RAIU: Safety Advice Notice

SAN 001: Suitability of Fixed Buffer Stops

Photograph 2 – Location of buffer stop involved in the accident, now with concrete block

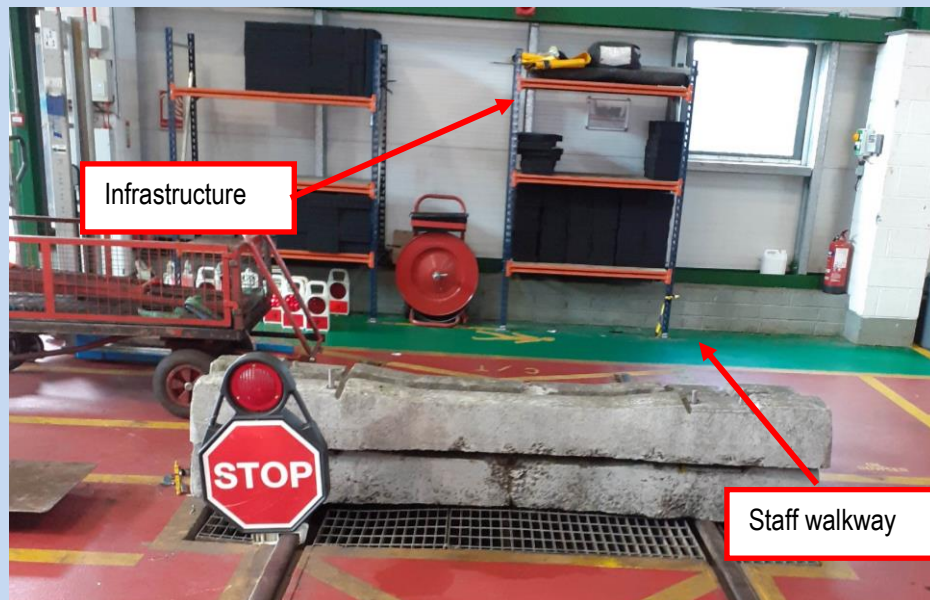
Note: The measurements from the face of the buffer to the inside staff walkway and to the infrastructure wall are 2600 mm and 3900 mm, respectively.

The RAIU conclude that a fixed buffer stop is not suitable at the location where the accident occurred in LTCD, as it does not adequately protect the staff (at its current distance of 2600 mm from walkway) and does not adequately protect the shed infrastructure (at its current distance of 3900 mm from the structure).

SAN Date	02/10/19
SAN Title	Suitability of Fixed Buffer Stops
SAN Number	SAN 001
Issued to	IÉ-IM & and CRR
Implementer	IÉ-IM
System/Equipment	Buffer Stops
Safety Issue Description	The fixed buffer is not suitable in depot locations which are close to staff walkways and structures.
Circumstances	ICR 16 moved unintentionally at slow speed, striking and damaging a friction buffer stop.
Consequences	The safety consequence as a result of the unintentional movement of a rail vehicle at speed would be injuries to staff and potential structural damage.
Reason for Issue	To prevent the possibility of injury to staff and damage to structures.
Safety Recommendations	<p>SAN001-01: IÉ-IM should review the selection of fixed buffer stops at locations at LTCD for their suitability and efficacy in protecting staff and infrastructure.</p> <p>SAN01-02: IÉ-IM should conduct review of their current specification for fixed buffer stops and their associated design forms to ensure they are fit-for-purpose; and fixed buffer stops are only selected where appropriate. Based on this review, IÉ-IM should commence a programme of inspections for fixed buffer stop at all locations on the IÉ network to ensure their suitability and effectiveness at protecting passenger, staff, track and infrastructure.</p>
